Re: Docket No. 70-925; License No. SNM-928  
Redefining the Licensed Area

ATTACHMENT 1  
PROPOSED REVISED FIGURES 6-1 THROUGH 6-3  
*FACILITY DECOMMISSIONING PLAN – REV 1*

ATTACHMENT 2  
PROPOSED REVISIONS TO SECTION 6.3  
*FACILITY DECOMMISSIONING PLAN – REV 1*

**FIGURE 6-3**  
**LICENSED AND CONTROLLED**  
**AREAS - SITE WIDE**  
**FACILITY DECOMMISSIONING PLAN**  
**REVISION 1**

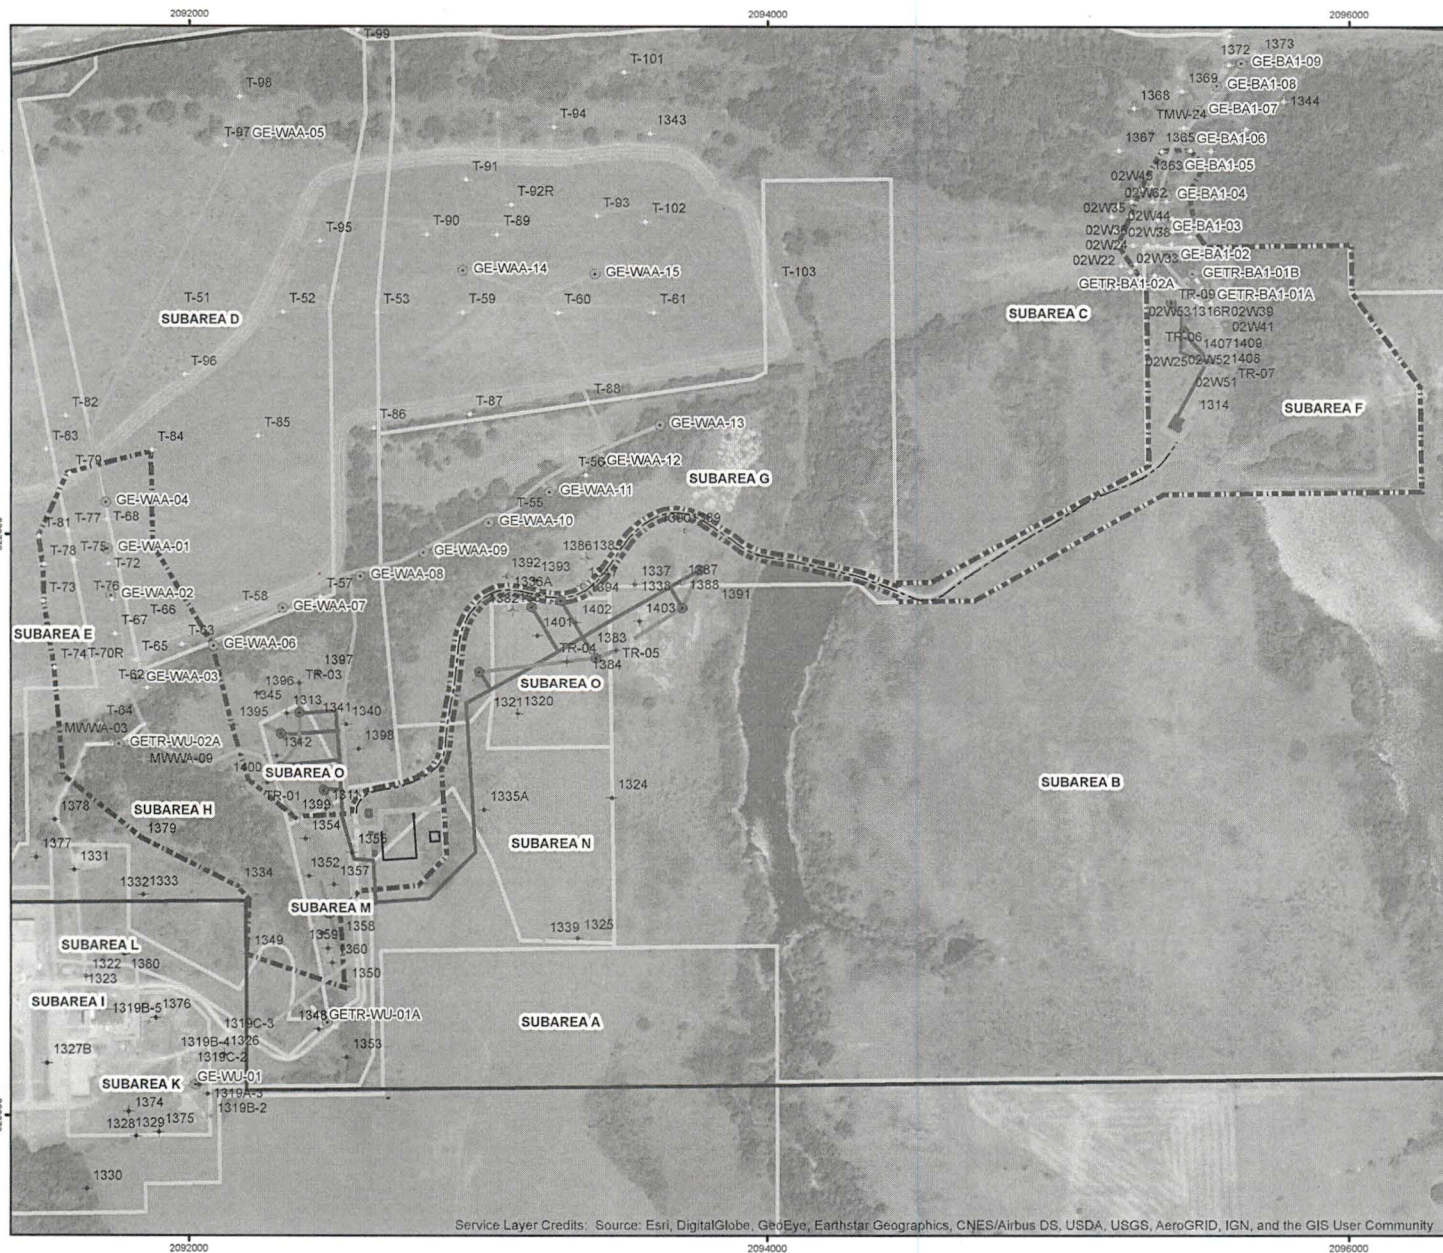
Attachment 1 to this letter provides revisions to Figures 6-1 and 6-2, and includes a new Figure 6-3, which depicts the areas shown in Figures 6-1 and 6-2, extending the licensed area along the road over which spent resin will be transported from the BA1 treatment facility to the WATF for processing, packaging, and shipping. Attachment 2 contains proposed revisions to Section 6.3 of the DP, which requests a license amendment to redefine the licensed area as the area shown in Figures 6-1 through 6-3.

Vessels containing spent resin will be transported from the BA1 treatment facility to the WATF along this road. Figure 6-3 depicts the entire proposed licensed area, which includes portions of Subareas C, D, E, G, H, M, N, and O. This figure shows that a "corridor" extending 5 meters from either side of the centerline of the site road has been added between the two large licensed areas. Vessels containing spent resin will be transported from the BA1 treatment facility to the WATF along this road.
